Access Compliance Report Public Rights-of-Way (Curb Ramps)

Cross Street: STARNES RANDALL RD Intersection ID: N/A Main Street: FIRST RUN CT Location: SE **Overall Compliance: No** 0 **ADA ID: 34FF0D5E637E** Ramp Type: Combination2Diag Initial Pass/Fail: Fail **Severity Score:**

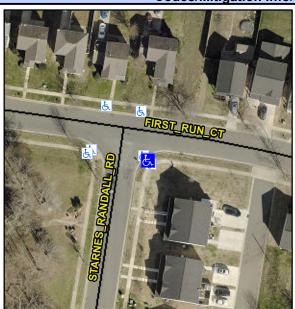
83.5 No

48.0 No

Street 1 Name None **FIRST RUN CT** Stop Condition-Street 1 Street 2 Name StopSign Stop Condition-Street 2 STARNES RANDALL RD Possible Solutions: Remove & Replace Curb Ramp With Two New Directional Ramps or Equivalent. Surveyor Notes: N/A PROW/ADA: R304.5.1, R304.2.2, R304.5.3, R304.3.2
